DOMINION NUCLEAR CONNECTICUT, INC.
MILLSTONE POWER STATION UNIT 3
RESPONSE TO REQUEST FOR ADDITIONAL INFORMATION REGARDING
A SPENT FUEL POOL CRITICALITY LICENSE AMENDMENT REQUEST

RESPONSE TO RAI QUESTIONS 21 and 24
REGARDING THE SPENT FUEL POOL CRITICALITY LICENSE AMENDMENT
REQUEST

Figure 1: Minimum Fuel Assembly Burnup and Decay Time Versus Nominal Initial Enrichment for Region 2 Storage Configuration

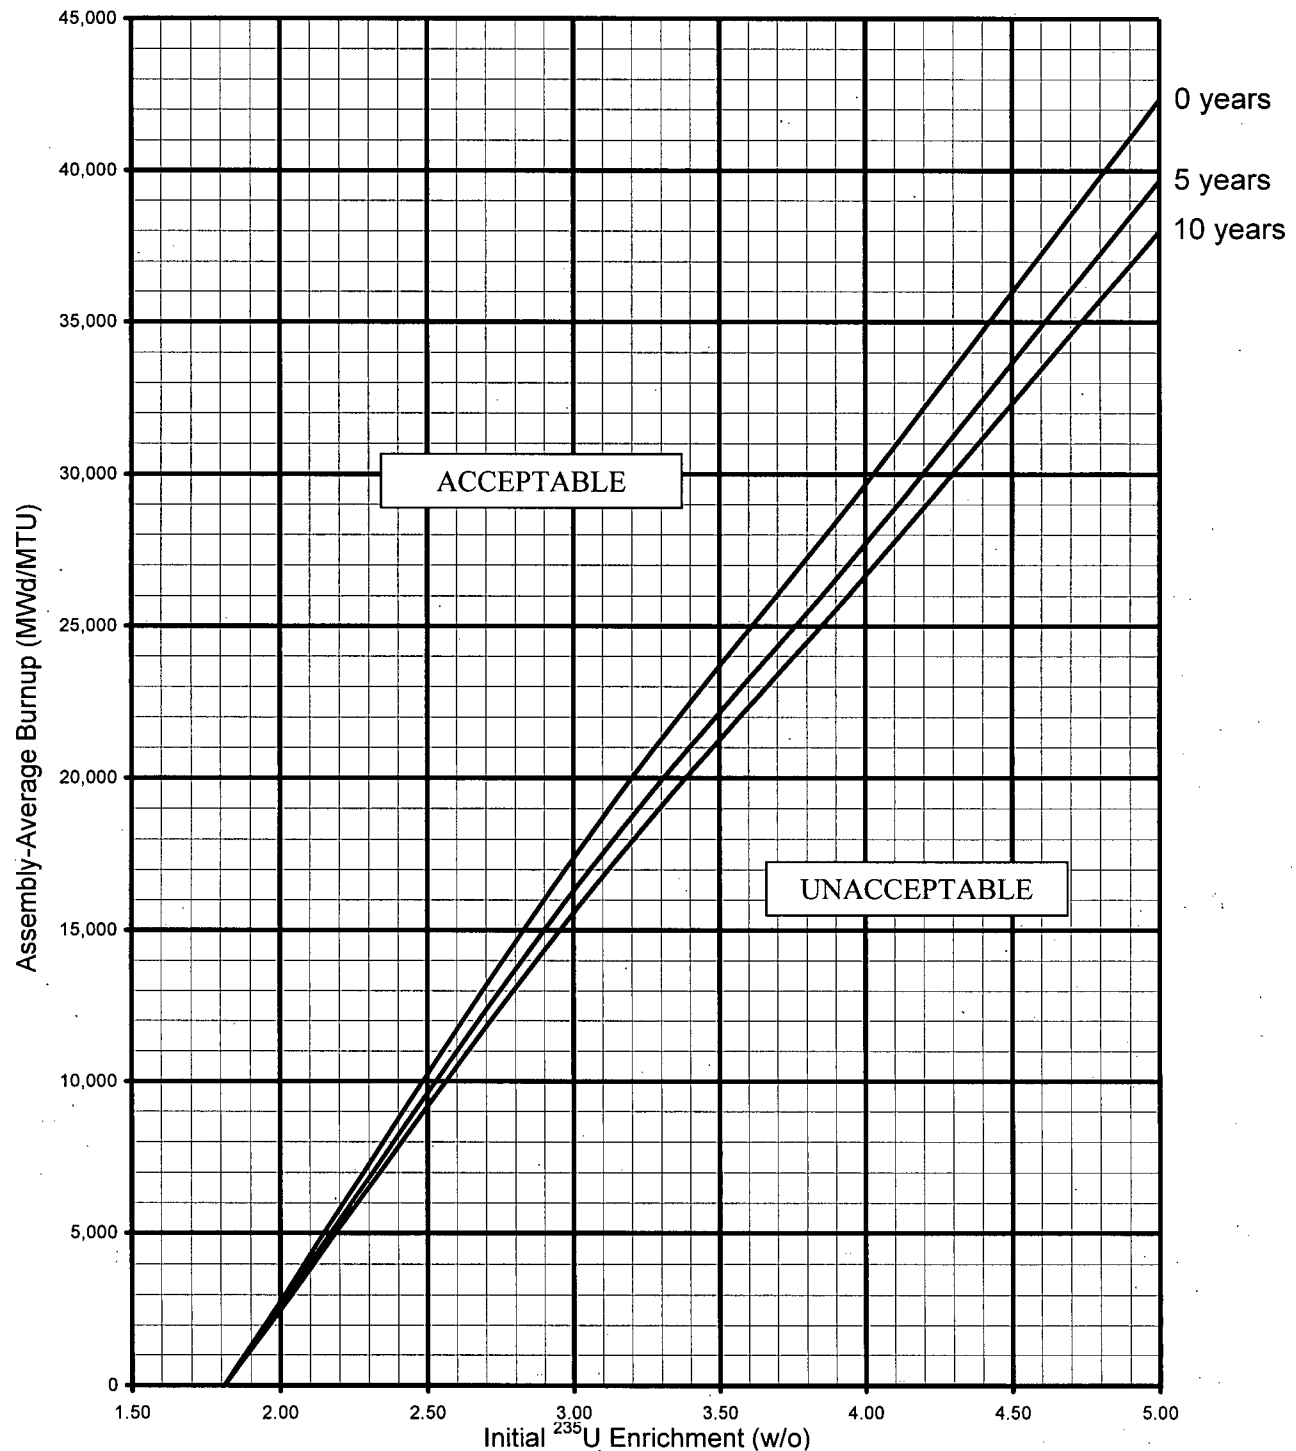
In the response to RAI 1 - 3 regarding the axial burnup distribution modeling, it is stated that Profile 5 from NUREG/CR 6801, "Recommendations for Addressing Axial Burnup in PWR Burnup Credit Analyses," March 2003, was used. In NUREG/CR-6801, Figures 3 and 7 - 18 show various profile shapes at various burnup intervals. Additionally, Figures 19 - 30 statistically demonstrate the bounding profile for various burnup intervals. Demonstrate Profile 5 is bounding for all MPS3 fuel axial burnup profiles, in particular the 15-25 gigawatt day per metric ton uranium (GWd/MTU) range.

To implement this restriction of no future use of No Blanket fuel at MPS3, a footnote will be added to proposed Technical Specification Figure 3.9-3 for Region II fuel storage, and Figure 3-9-5 for Region III for storage of Post-Uprate fuel. Figures 1 and 2 show this footnote.

The footnote reads: "For assemblies from Post-Uprate (3650 MWt) Cores, the nominal fuel enrichment of blankets must be ≤ 2.6 w/o U-235, and nominal blanket length must be at least 6 inches on both ends of the fuel." The restrictions contained in this footnote ensure fuel is within the analyzed conditions of the analysis in this RAI response.

Based on the results in Table 21-6, the Region II required fuel burnups at 3 w/o and 4 w/o U235 at all decay times are increased by 0.5 GWd/MTU. Based on the results in Table 21-6, the Region III required fuel burnups at 3 w/o U235 at all decay times are increased by 1.5 GWd/MTU.

The proposed revised tabular values for the Region II and Region III burnup/enrichment limits are provided in Table 21-7 (Region II) and Table 21-8 (Region III). These are plotted in Figures 1 (Region II) and 2 (Region III).

Figure 3.9-3 Minimum Fuel Assembly Burnup and Decay Time Versus Nominal Initial Enrichment for Region 2 Storage Configuration

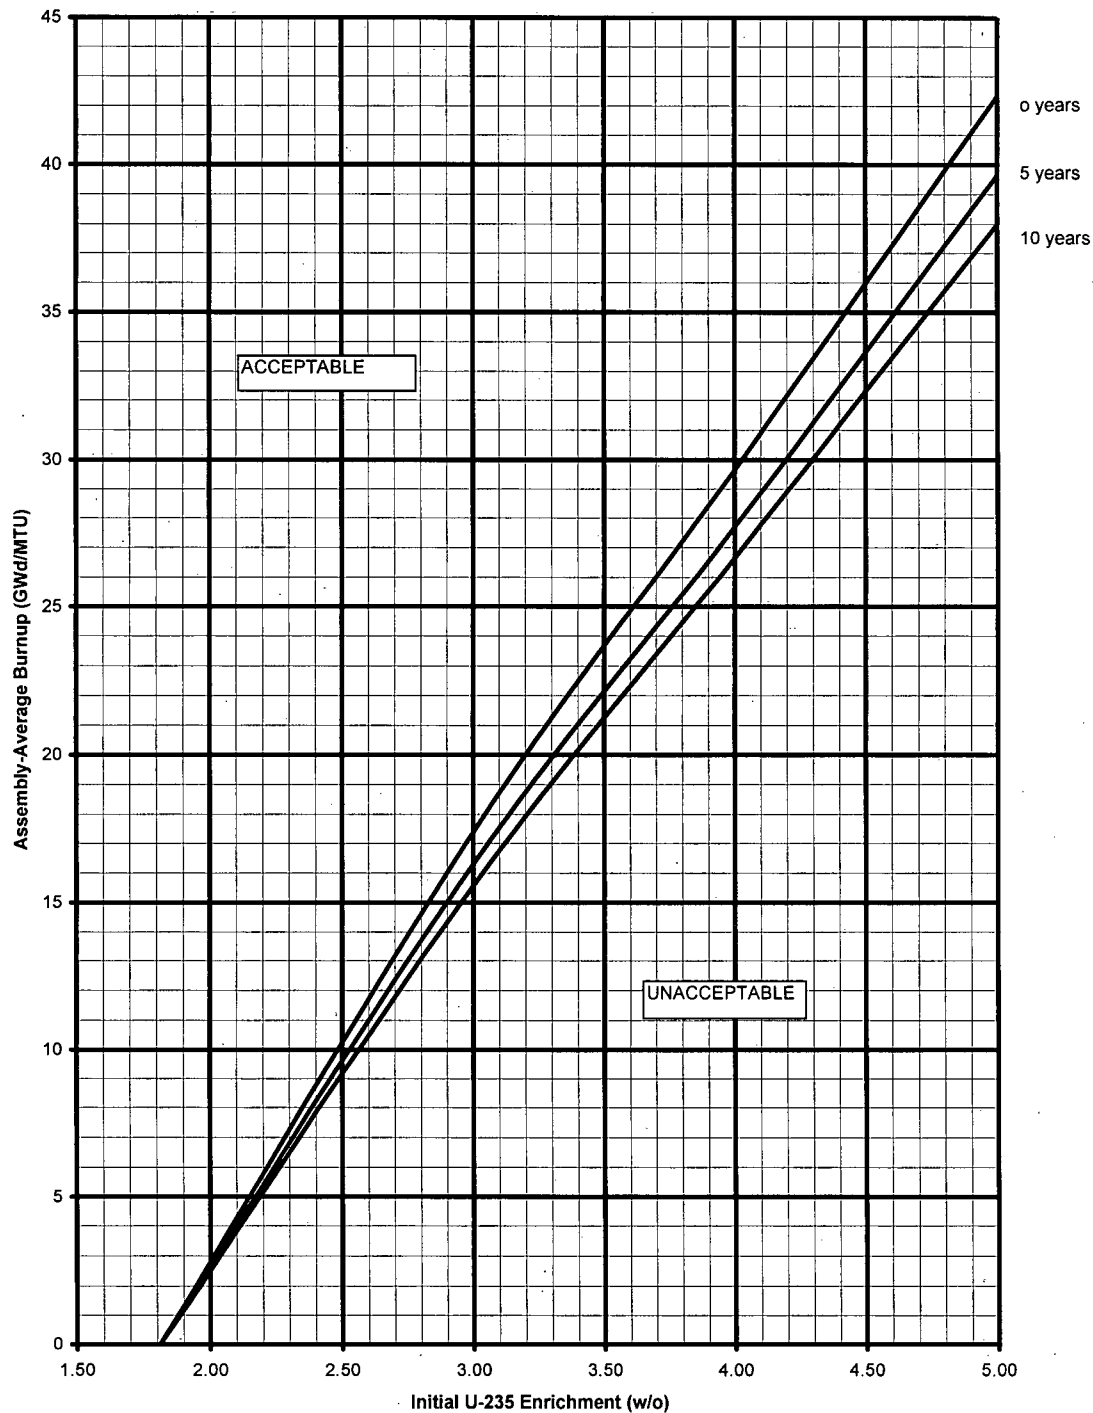
Attachment 1 contains the responses to RAI questions 21 and 24. The information in Figure 1 and Figure 2 in the response to RAI question 24 is used to update the information provided in DNC letter dated July 13, 2007 (ADAMS No. ML072000386), Attachment 3, "Mark-up of The Operating License and Technical Specifications Pages," Figure 3.9-3 and Figure 3.9-5. The updated Figure 3.9-3 and Figure 3.9-5 are provided in Attachment 2.
